## **Waterloo Metro Over Station Development**

### **Basement Car Park - S4.55 Modification – Traffic Statement**

ptc. have been engaged by the Waterloo Integrated Station Development team to provide a traffic statement to accompany the Section 4.55 modification for the proposed Basement Car Park as part of the Waterloo Metro Over Station Development.

Figure 1 – Proposed Basement 1 Modification

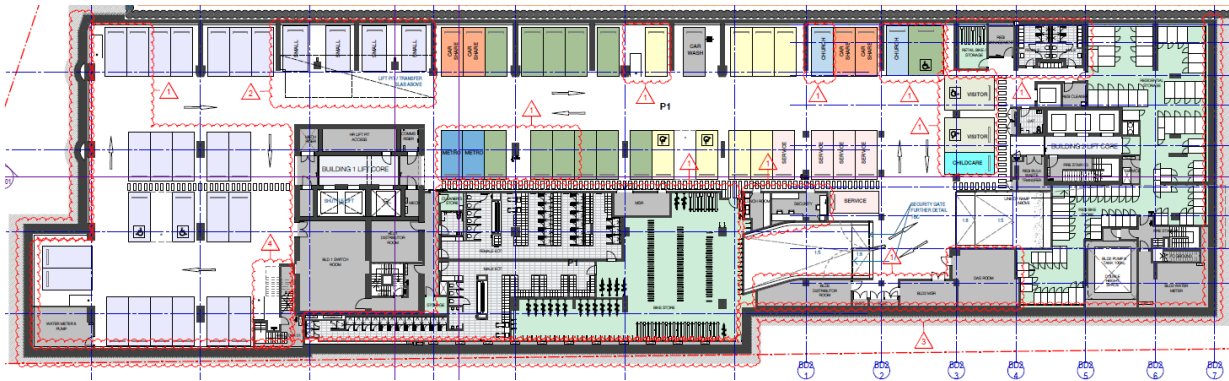
The modification will seek to amend the submitted layout to rationalise the configuration, to improve traffic flow and circulation, consolidate the residential parking onto Level P2 and adjust the end of trip facilities to be consistent with the Northern Precinct (SSD 10440) and Central Precinct (SSD 10439) State Significant Development Application requirements.

The revised basement layouts are shown in Figure 1 and Figure 2, while the modifications are outlined in Figure 5 and Figure 6.

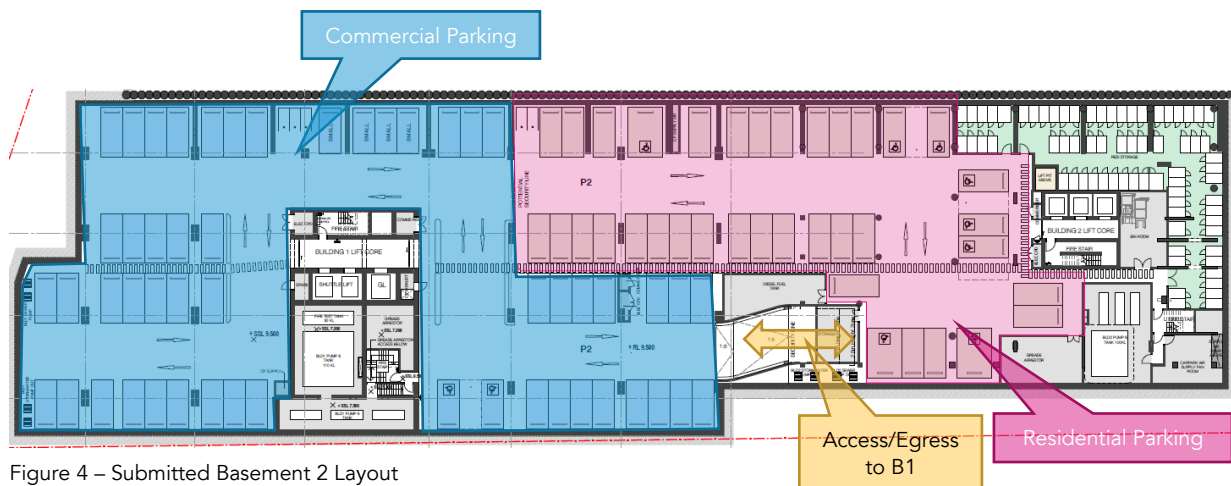
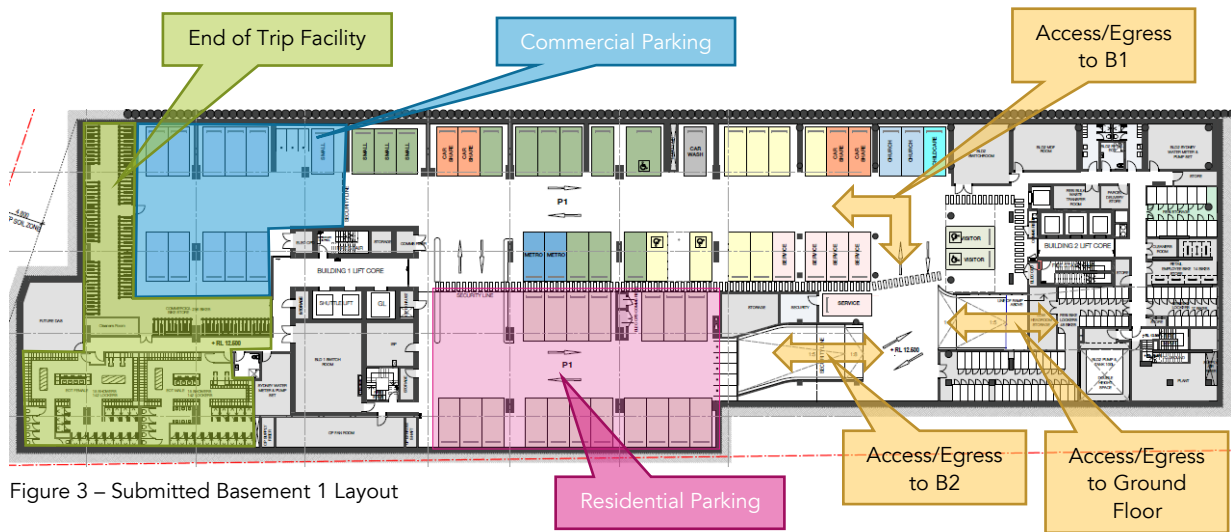
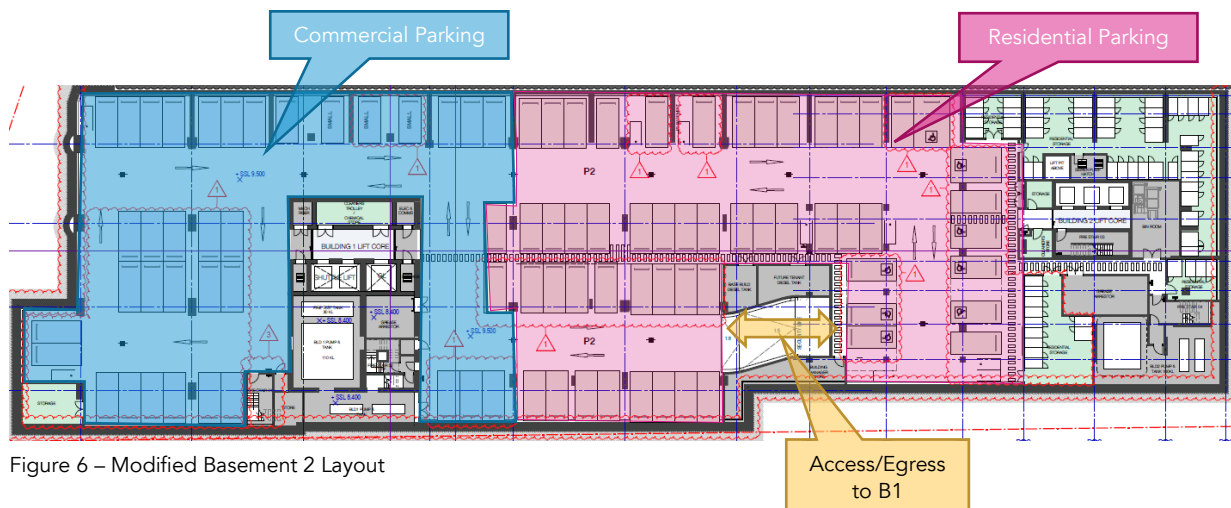
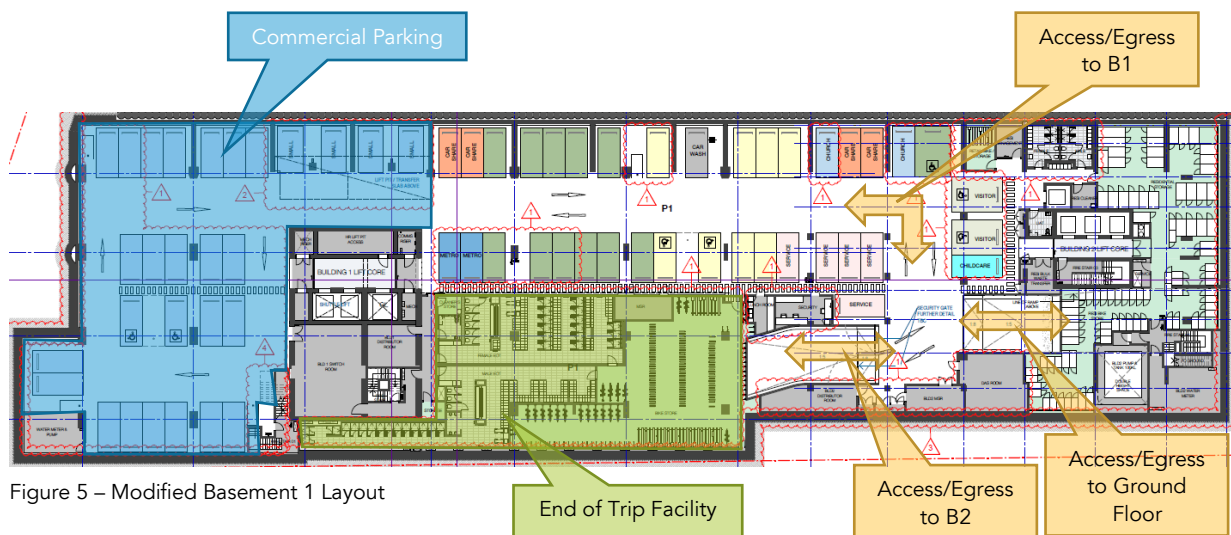
- Relocation of the End of Trip Facilities to align with the Northern and Central Precinct requirements,
- The removal of the dead end aisles in the northern sections of both levels of car park,
- The introduction of one way circulation aisles in the northern section of the car park on both levels, and
- The consolidation of the residential parking onto B1.

These plans are shown in Figure 5 and Figure 6 and Attachment 2.

- Reducing conflict points,
- Removing dead end aisles and therefore removing the potential 3 point turns and reversing movements,
- Improving access and egress to the End of Trip Facilities, and
- Providing a more segregated layout, improving wayfinding and user experience.
